Beachwood Planning and Zoning Commission Meeting Agenda - Amended
Thursday, February 27, 2025, 6:30 PM
at Beachwood City Hall, Council Chambers,
25325 Fairmount Boulevard, Beachwood, Ohio 44122

Subject: Fuchs Mizrahi School Expansion
Response to Review #1 Comments

RE: **P&Z 2024-44(A) Bialosky
Fuchs Mizrachi School
26600 Shaker Boulevard
Final Site Development Plan**

EXISTING SITE AND
DEMOLITION PLAN
V1.00

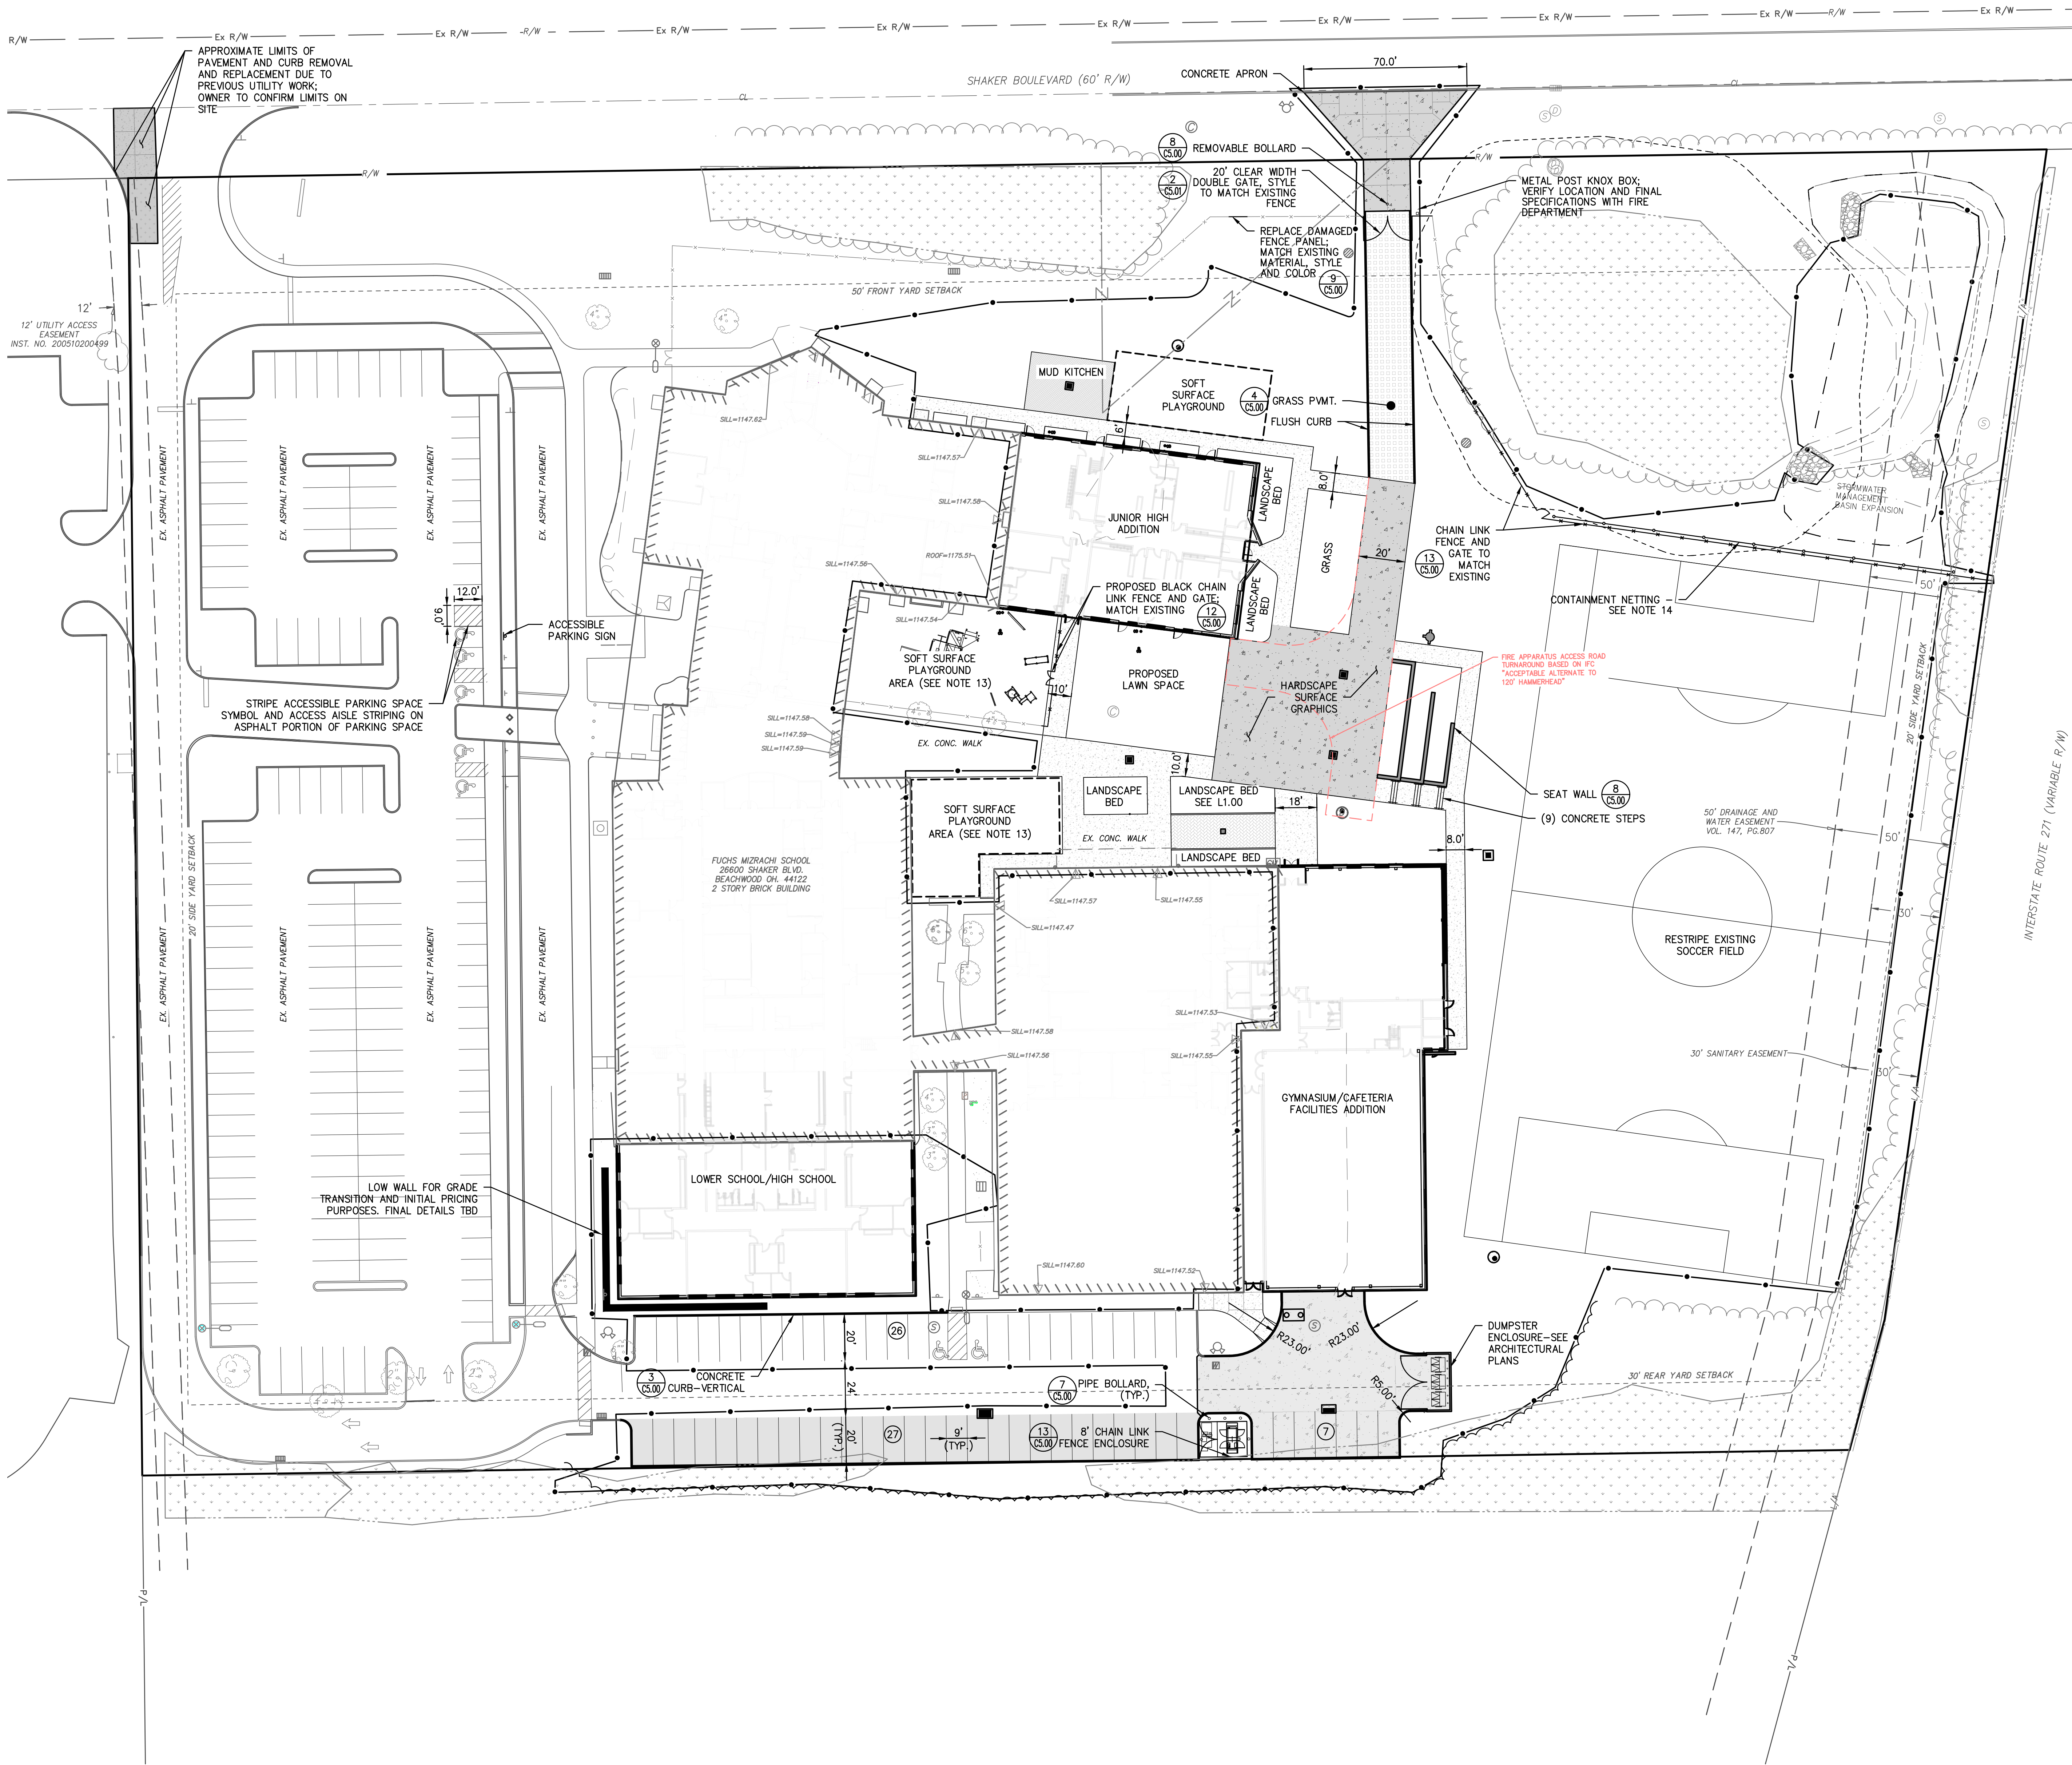
4. Near the center of the site, verify placement of Keynote #25 for water item to be removed. It appears to be on a portion of the water main to remain.

5. Keynotes 6, 26, 40, 42, 45, 50, 51, and 52 were not found in plan view.

6. In the existing parking lot area south of the new Lower School/High School addition, verify keynotes for the following: a. Concrete sidewalk to stay should be labeled. b. Asphalt pavement to remain should be labeled. c. Verify the labels for existing light poles. d. Label existing sanitary to remain.

Keynotes added to plan view or removed from keynotes

SITE UTILITY PLAN

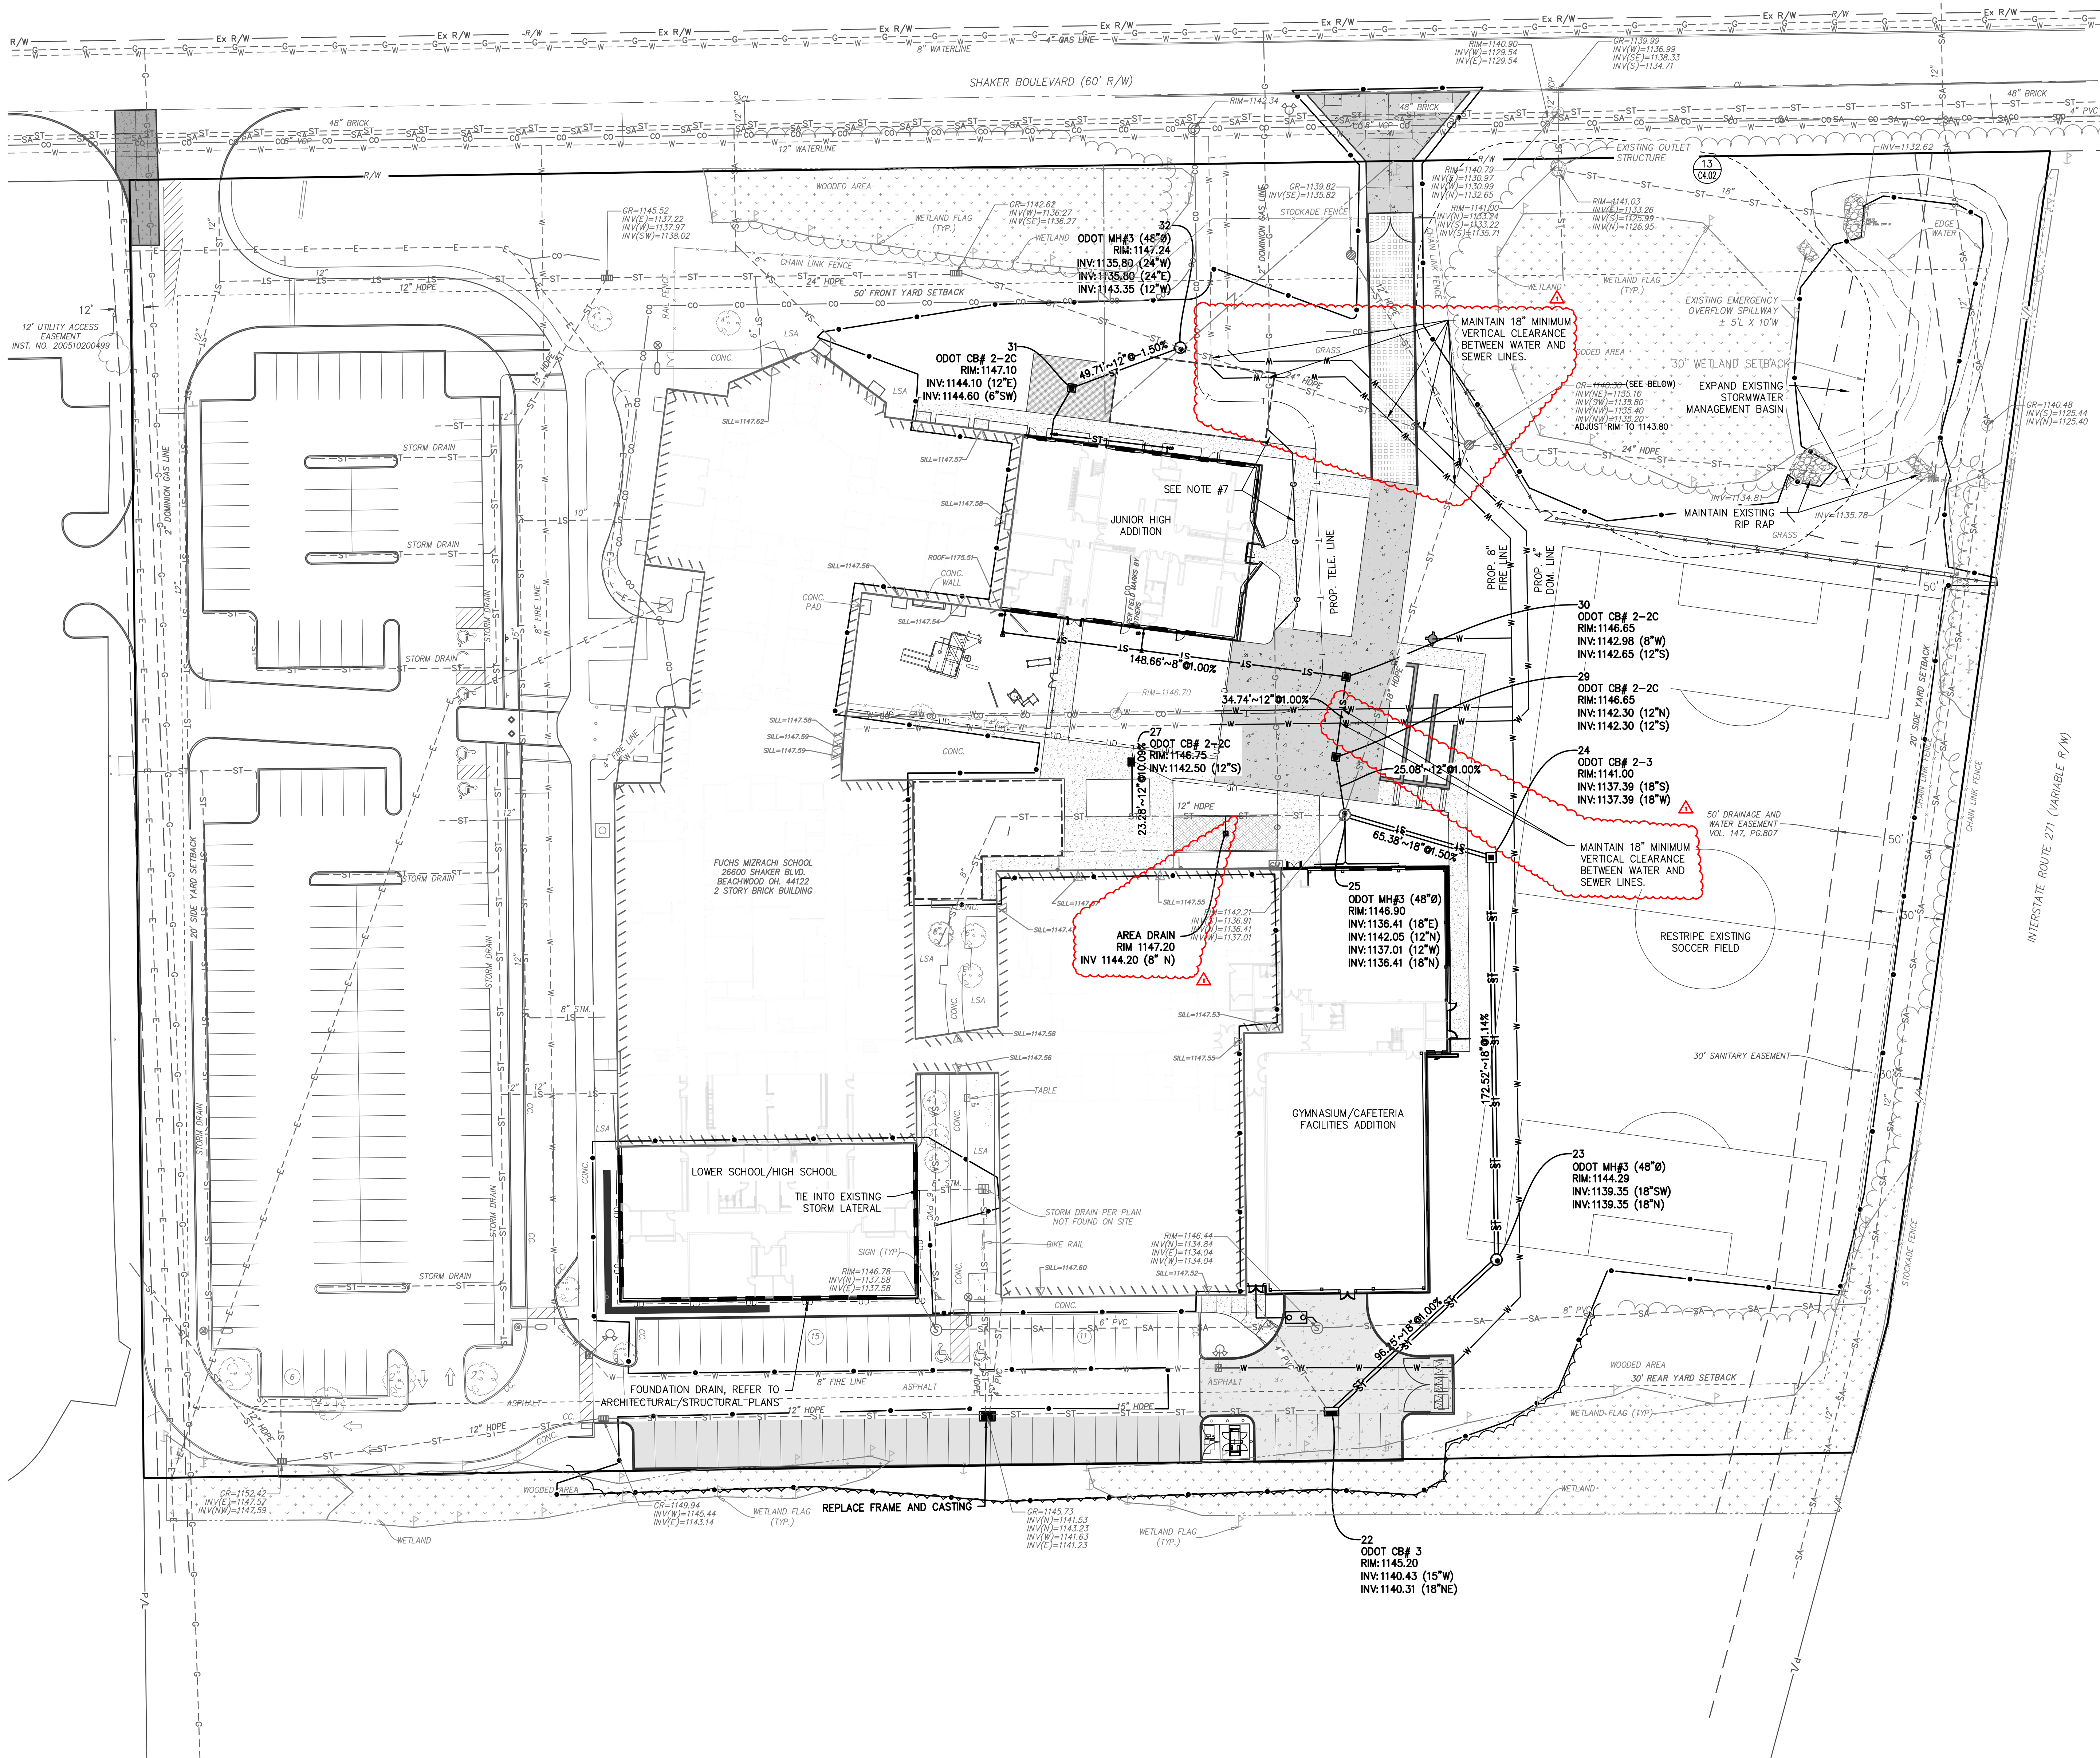
12. SWPP Plan Note #4 references a sediment basin. No information for a sediment basin is provided in the plans. If a sediment basin will not be used, applicant needs to show that the silt fence and inlet protection provided do not exceed their design capacity. See Part III.G.2.d.ii of the NPDES Construction General Permit.

Note #4 was removed from plans
